**LEBANON PLANNING BOARD
MAY 20, 2024 - 7:00 PM
COUNCIL CHAMBERS, CITY HALL OR
REMOTE VIA VIRTUAL PLATFORM
LEBANONNH.GOV/LIVE**

- B. **Dartmouth Hitchcock Medical Center, 1 Medical Center Drive (Tax Map 10, Lot 8), zoned MC:** Applicant requests a Site Plan amendment to expand and reconfigure four existing parking lots and to widen a driveway, together with associated site improvements. **PB2024-12-SPA**

DARTMOUTH-HITCHCOCK MEDICAL CENTER

MAIN CAMPUS PARKING EXPANSION

C001

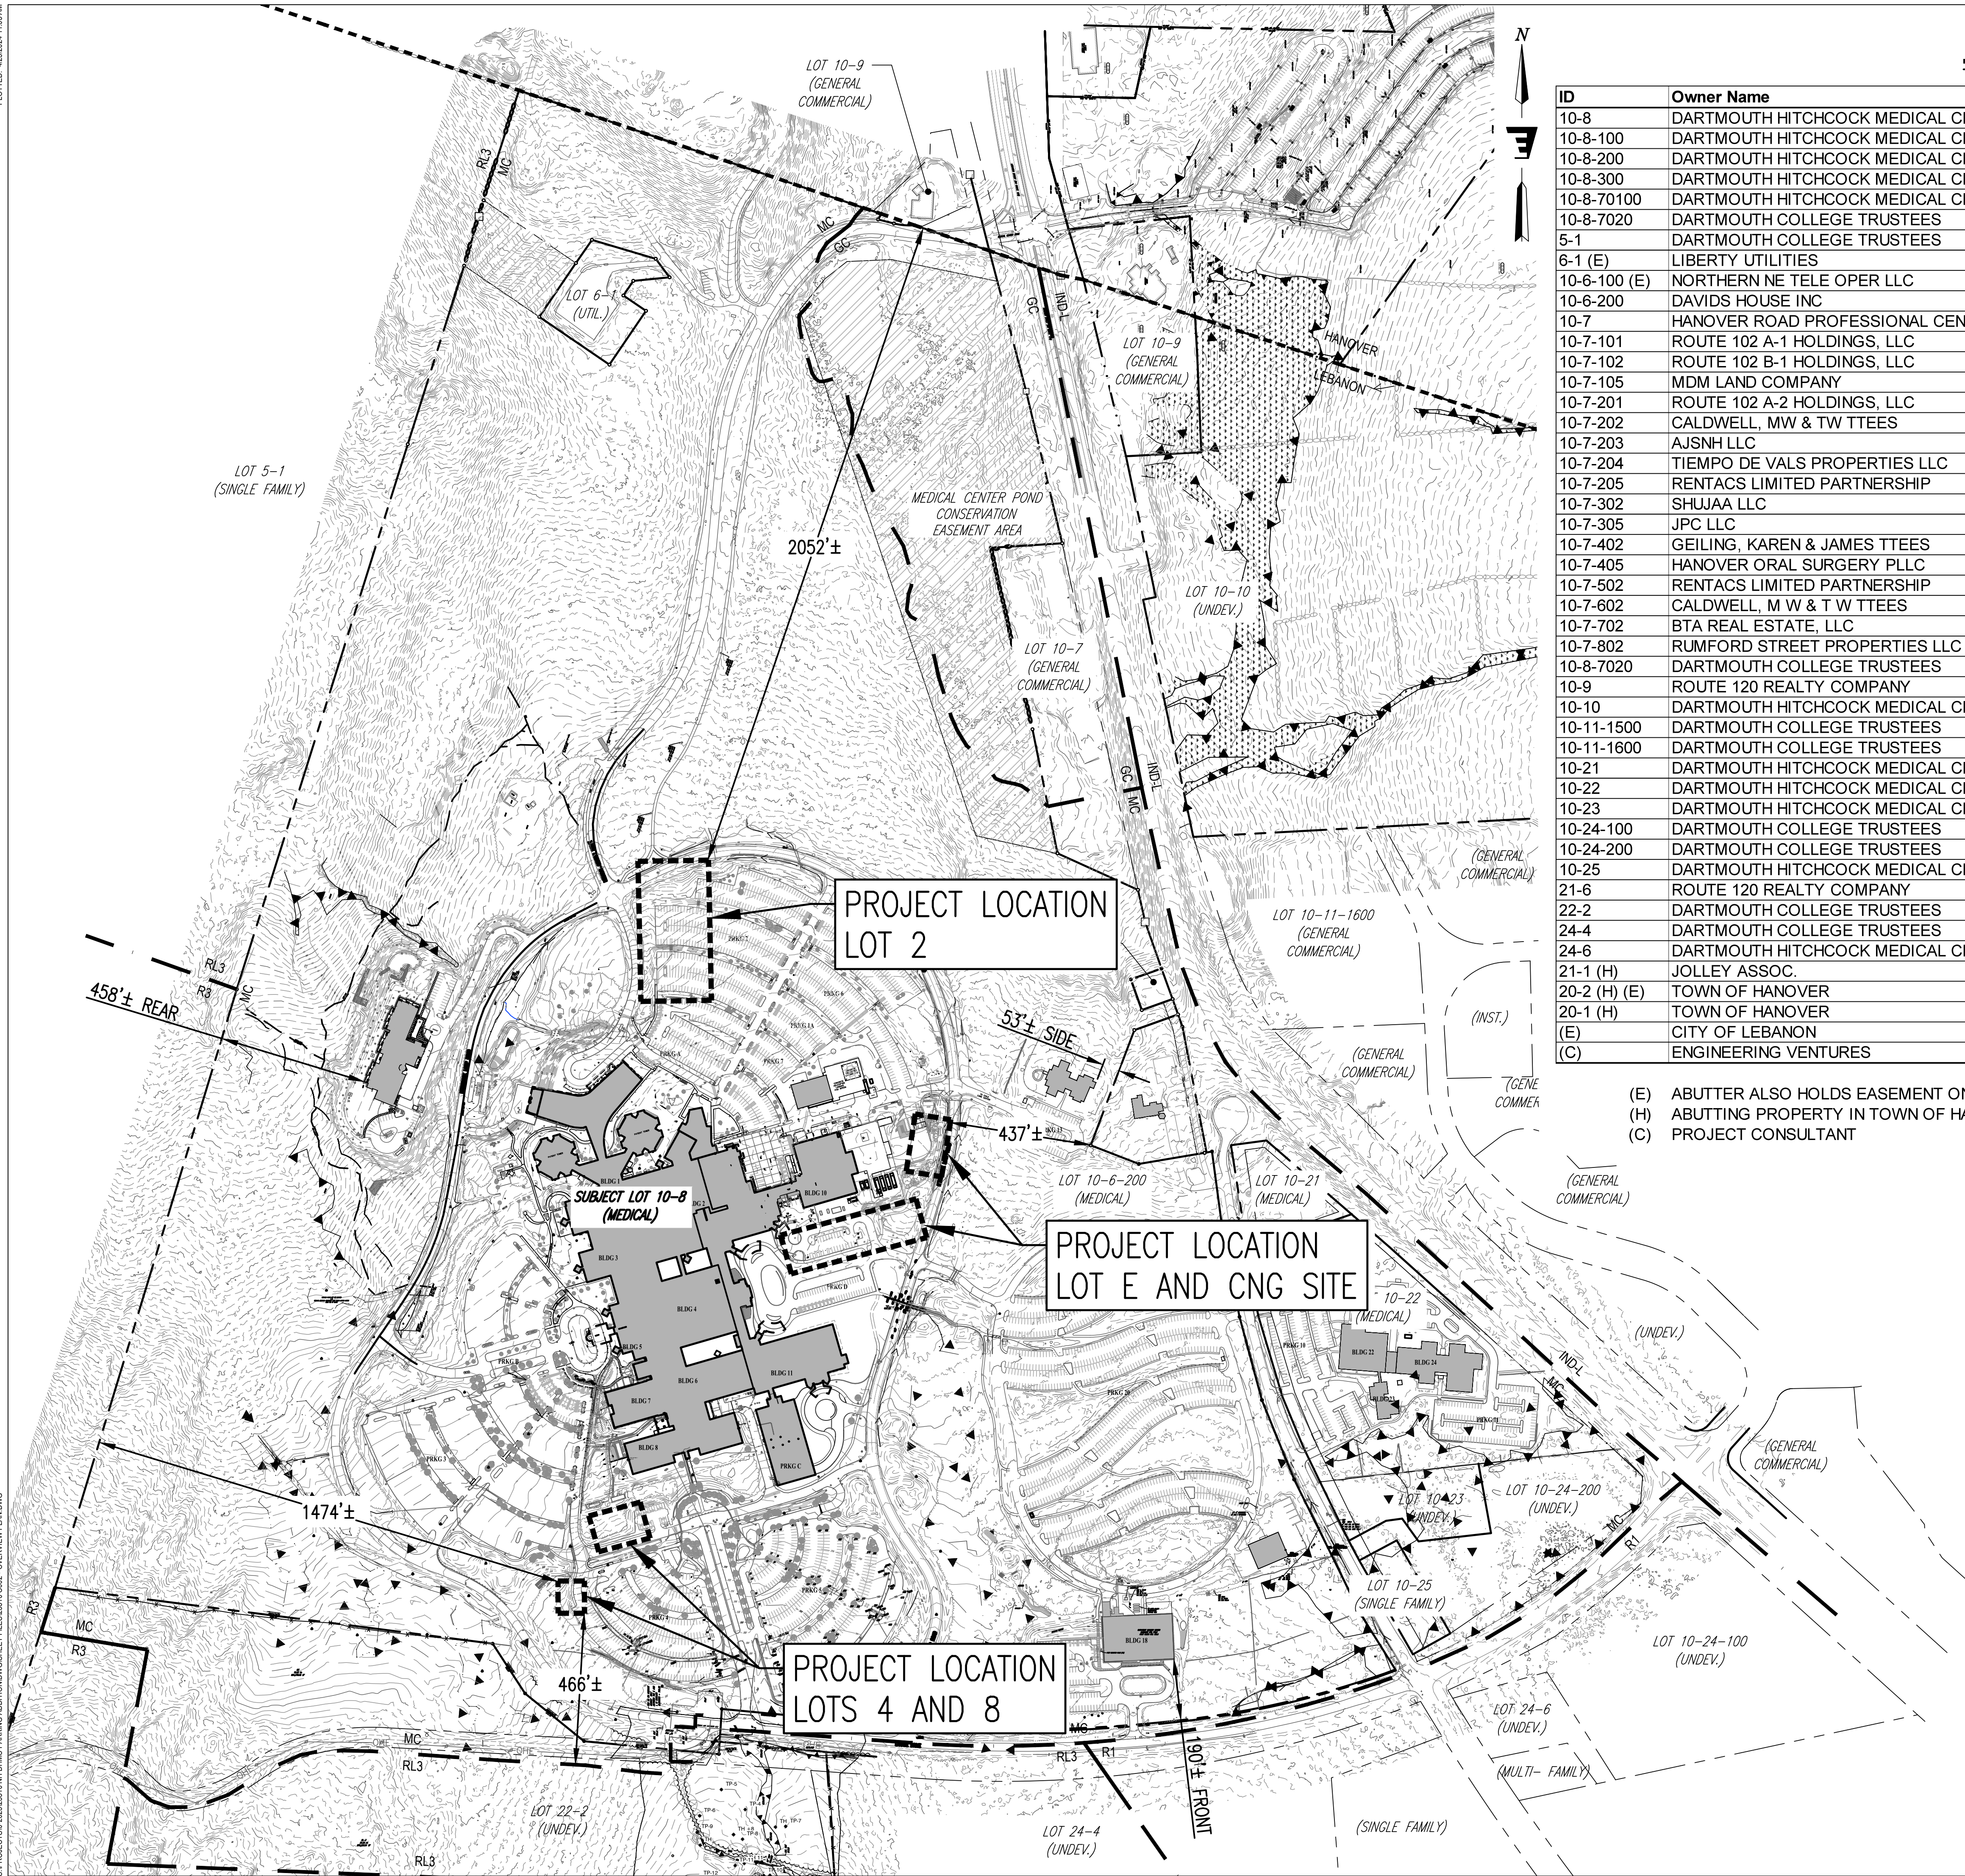
- Note No. 18 has been added to sheet C001. Additionally, the project includes new and expanded rain gardens which provide treatment for of stormwater from the expanded parking areas so that runoff is cleaned for it becomes groundwater.

C002
Page 3 of 27

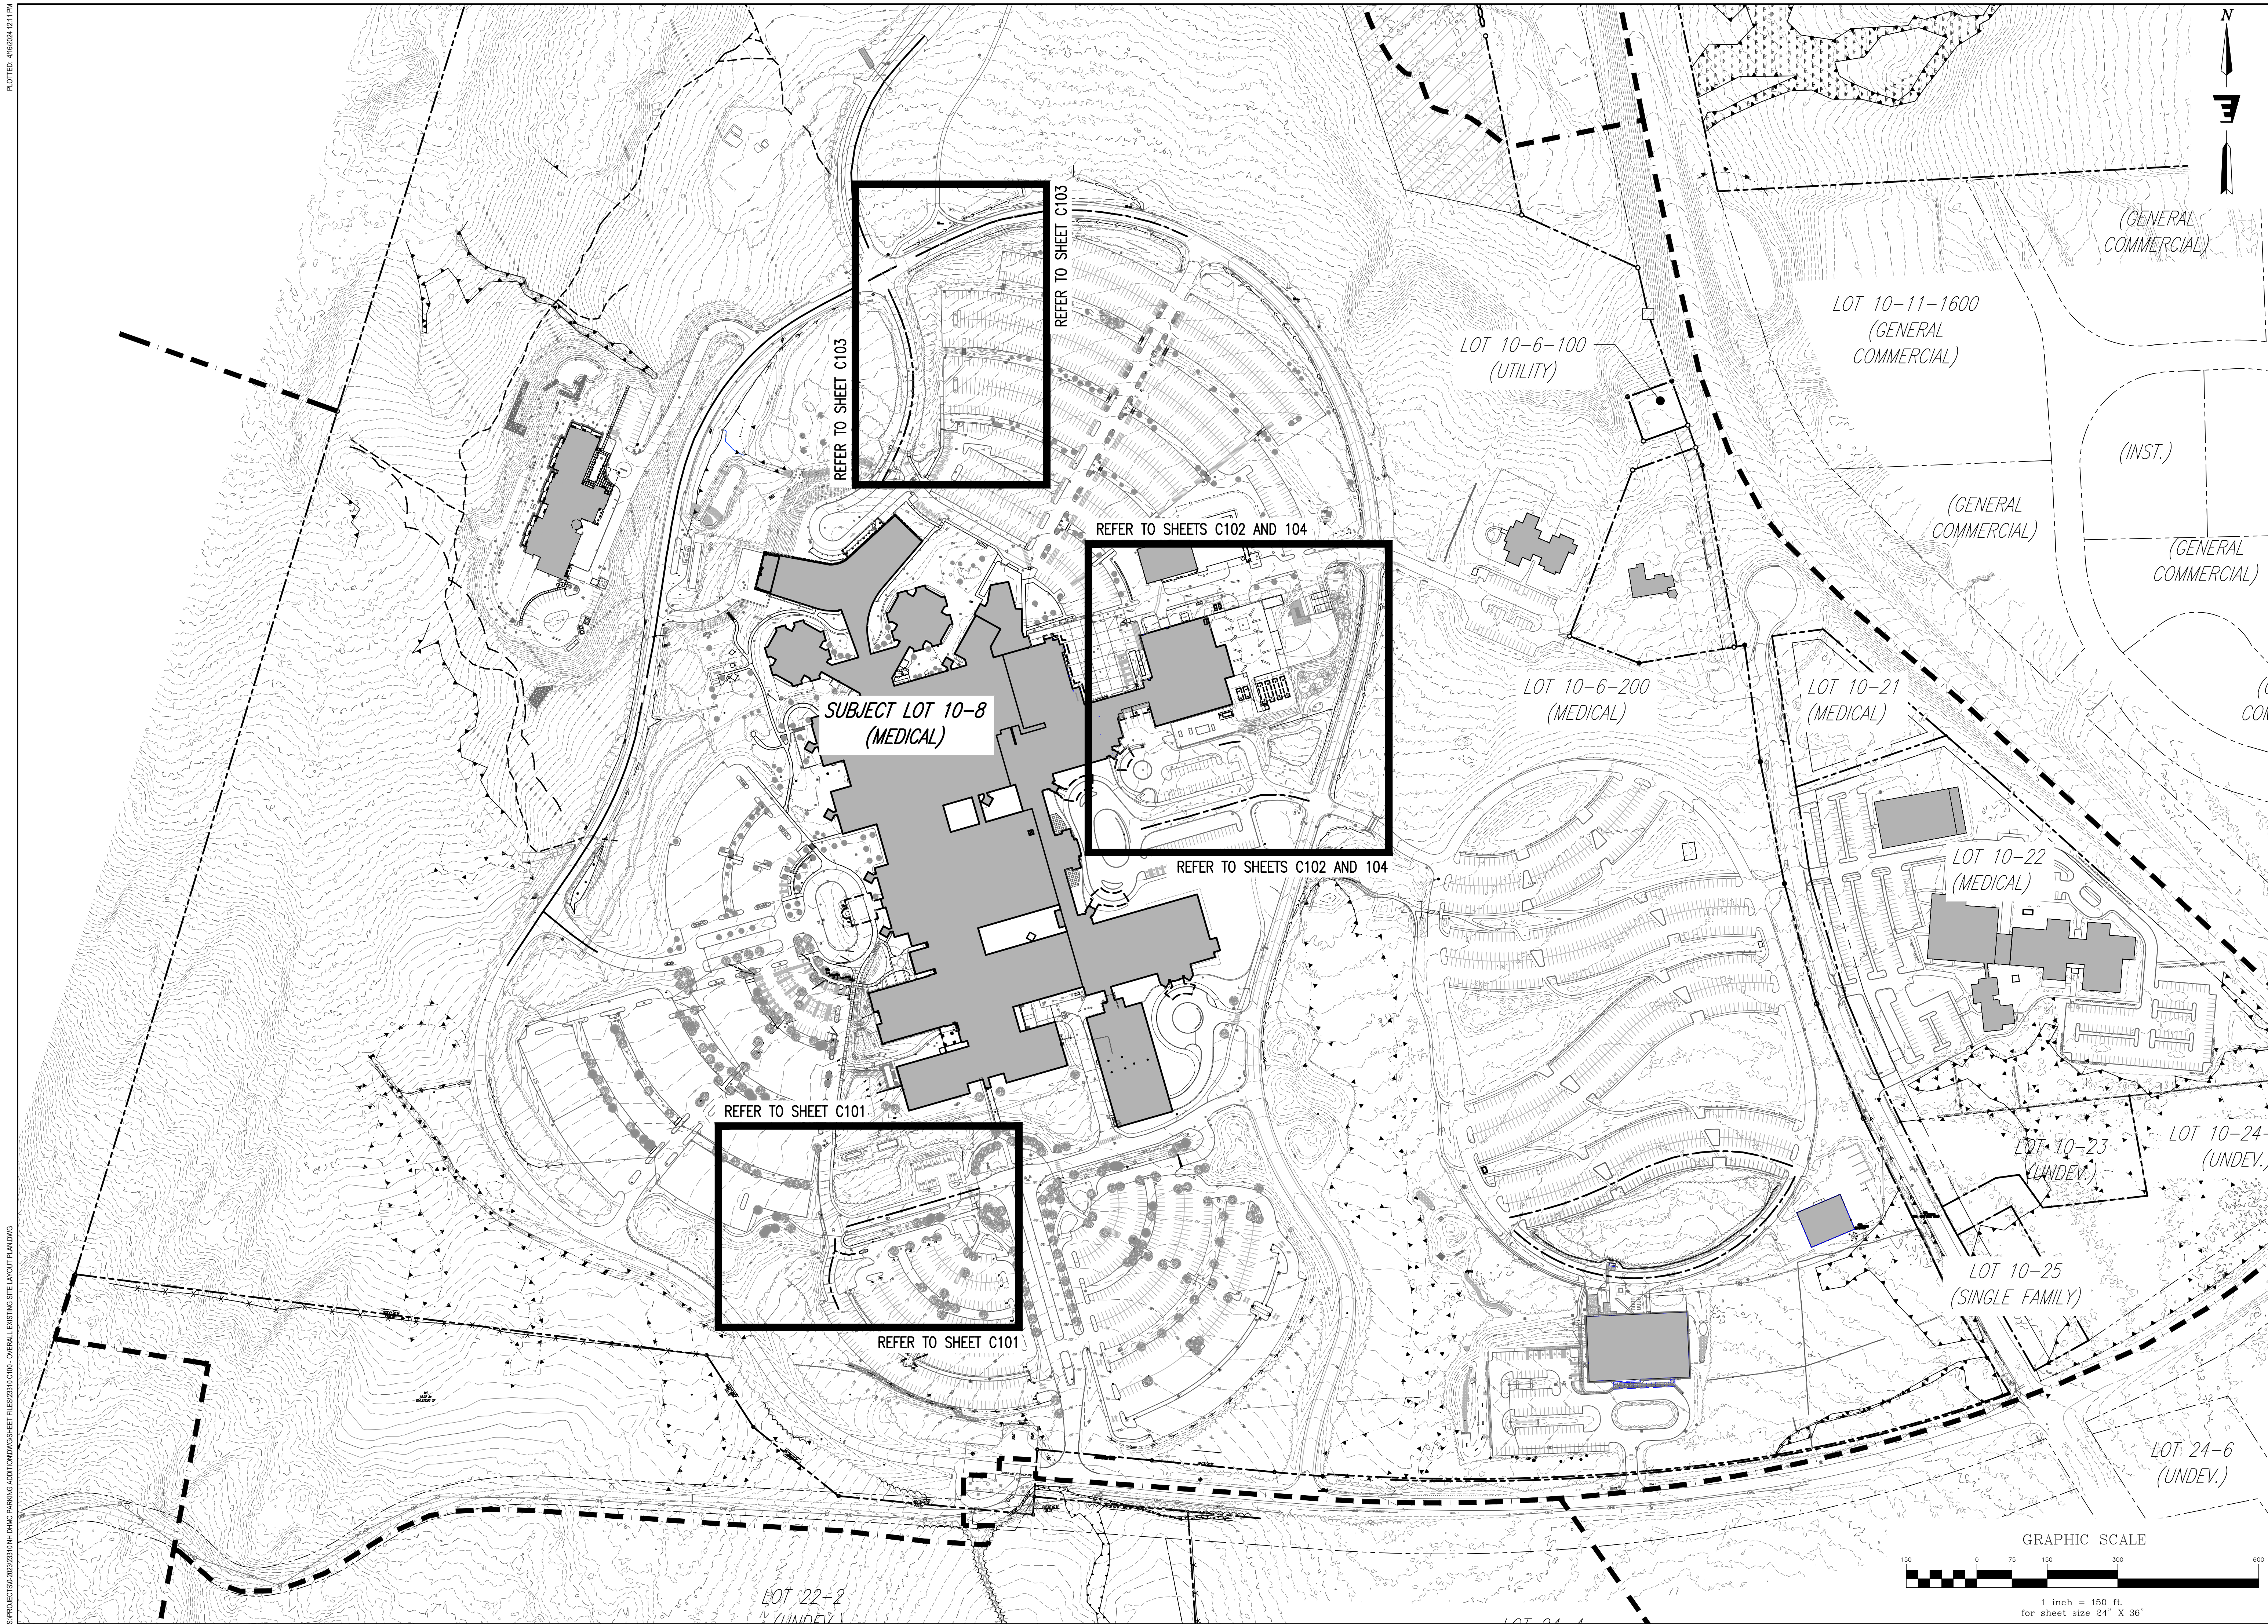
- Sheet 3 (C002)
 - Is abutter’s list up to date?
 - The abutter’s list has been verified and revised as needed.

- The revised Zoning Table now includes setback distances in the “Existing” and “Proposed Total” columns. Setbacks area also dimensioned on sheet C002.

C104

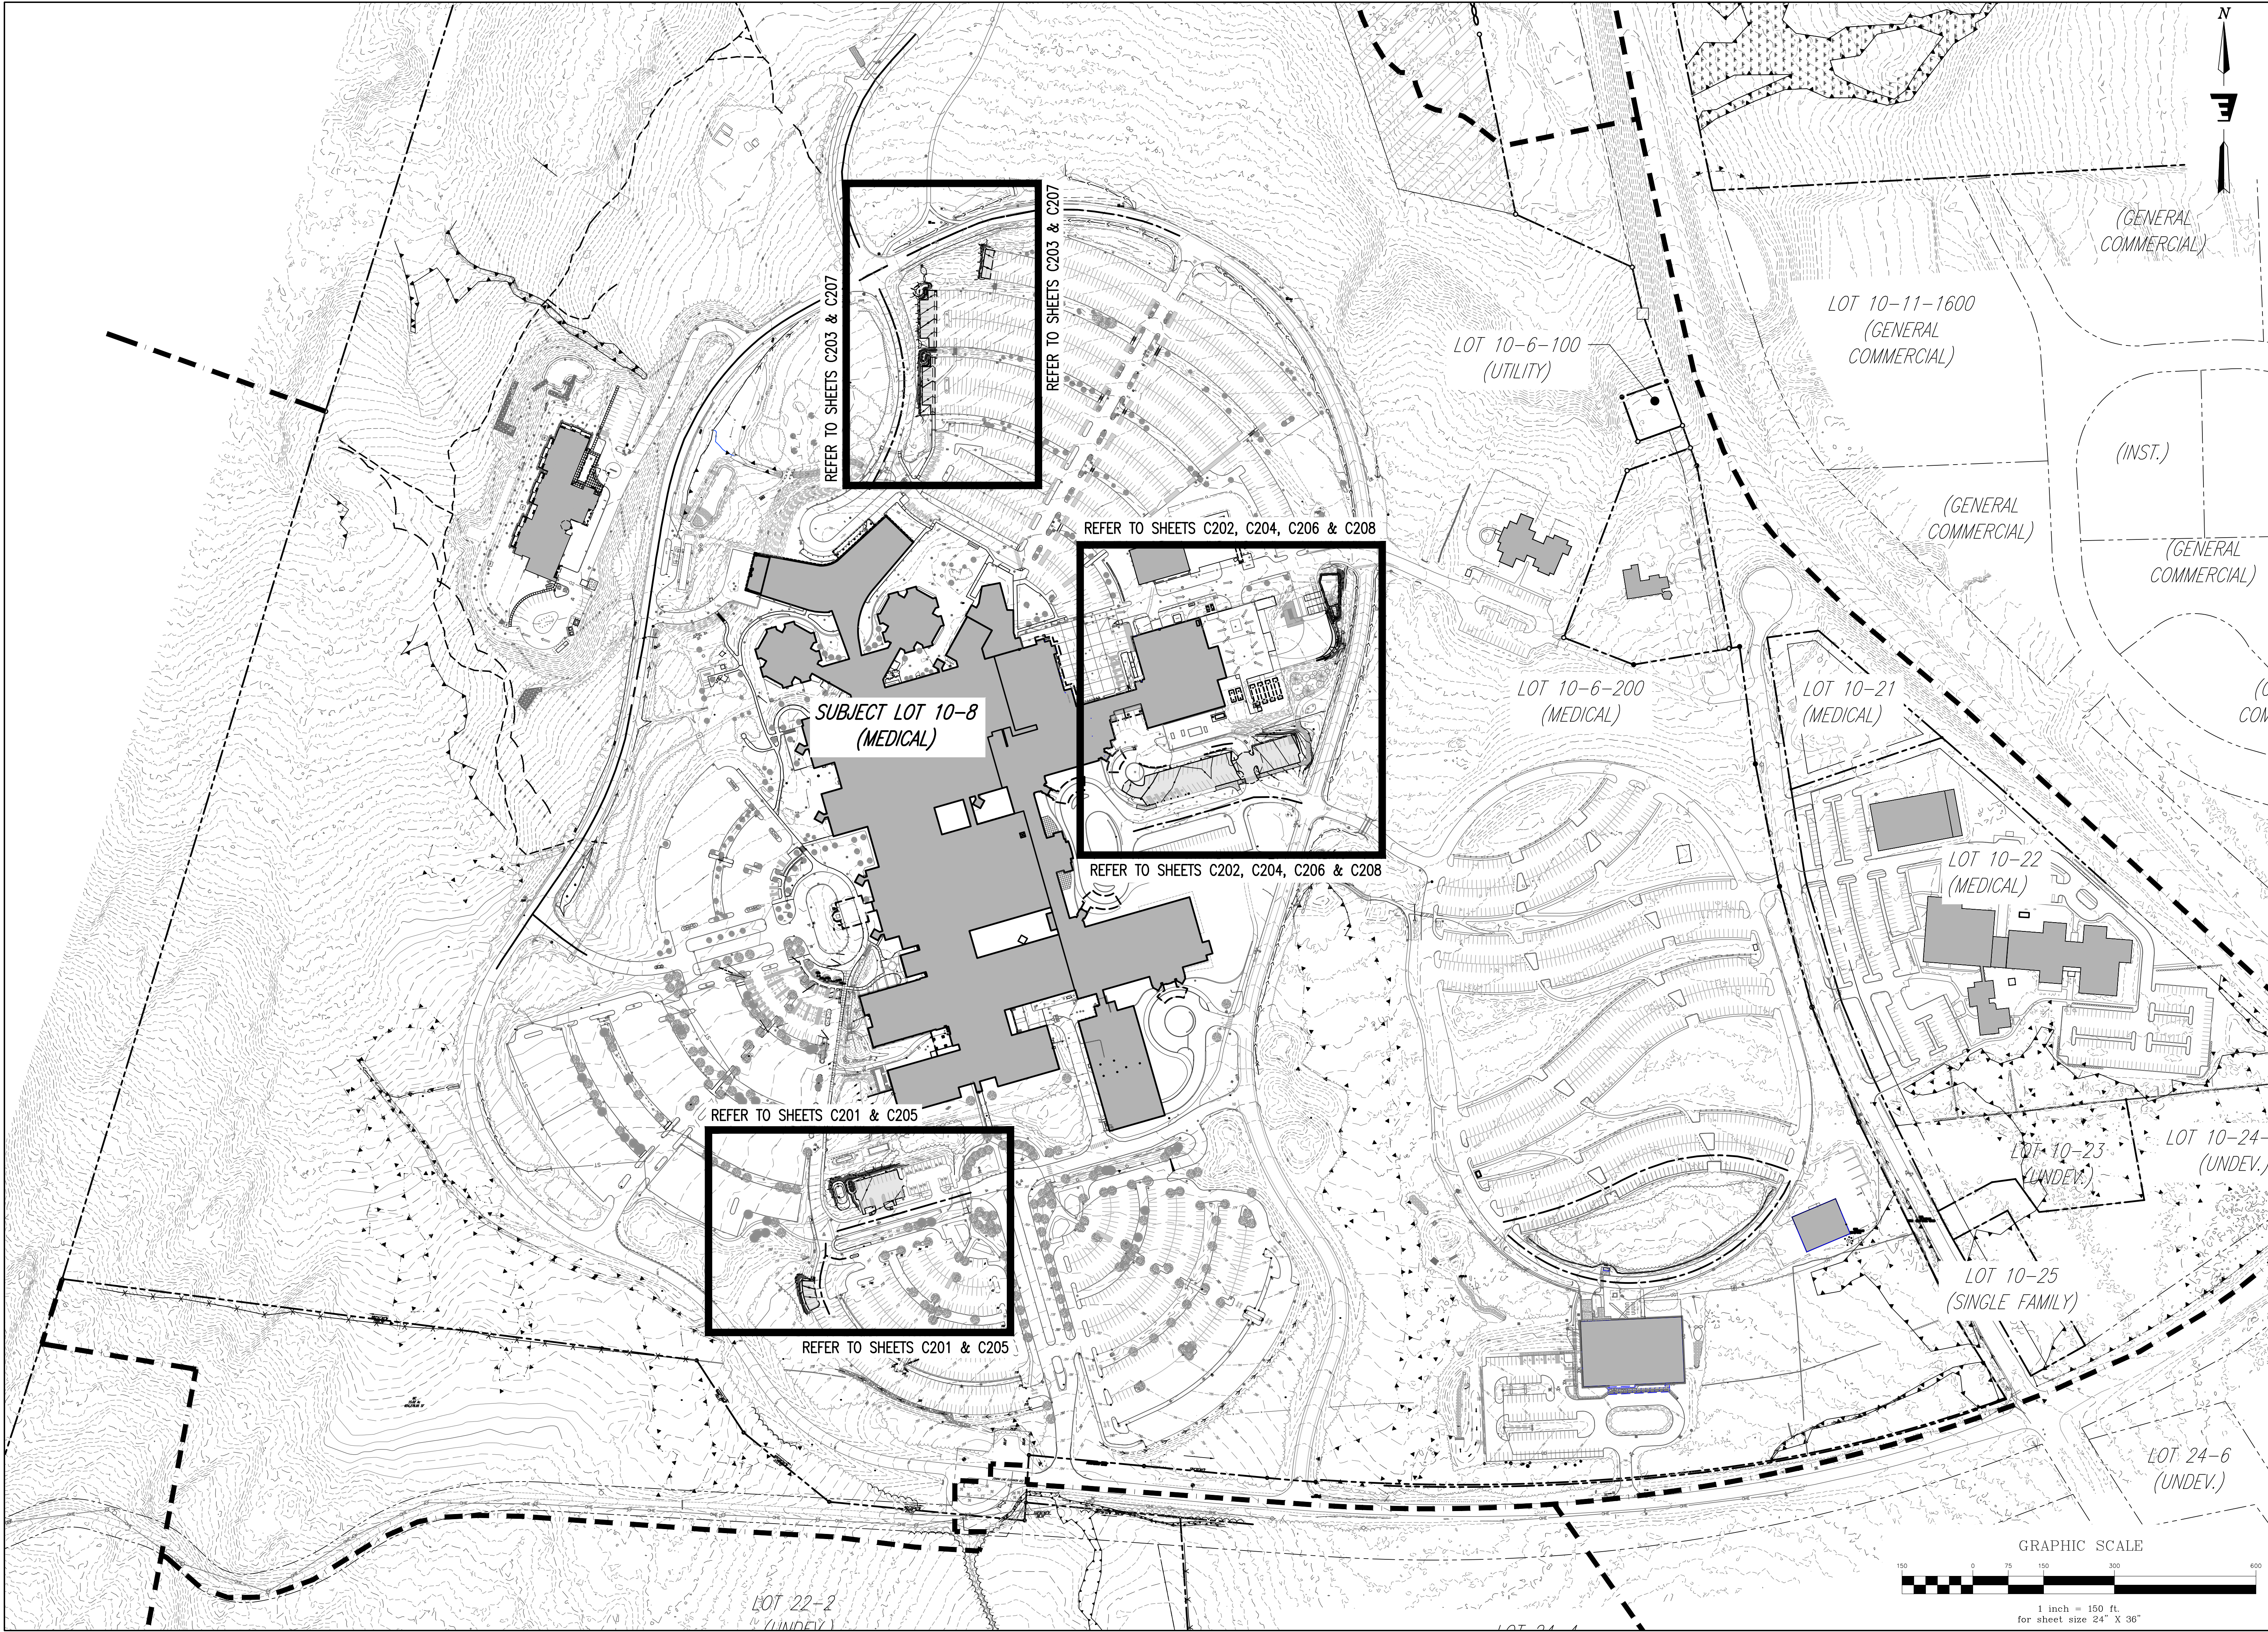
- Demo items have been added to existing conditions plans; sheets C101-C104
- **Sheet 8 (C104) is mislabeled along the bottom of the sheet as "SITE PLAN"**
